Notice of when closing the lid for AC brake electromagnet box

Subject	Notice of when closing the lid for AC brake electromagnet box	Date of issue	December 3, 2018
		MITSUBISHI ELECTRIC FA INDUSTRIAL PRODUCTS CORPORATION 1-1-1 Imajuku-Higashi, Nishi-ku, Fukuoka 819-0192 TEL 092-805-3400

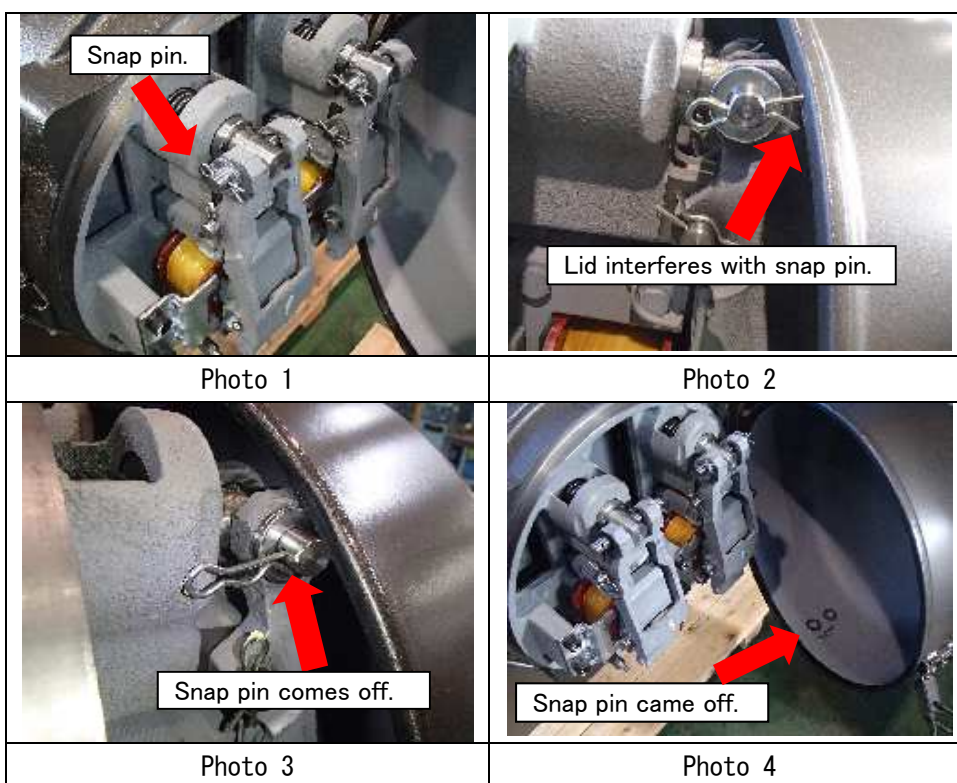
When closing the lid for AC brake electromagnetic box, there is a possibility that lid and the snap pin might interfere, thus cause the snap pin to come off. (Reference photos 1 to 4)
If the snap pin comes off, it may cause malfunction of the brake.
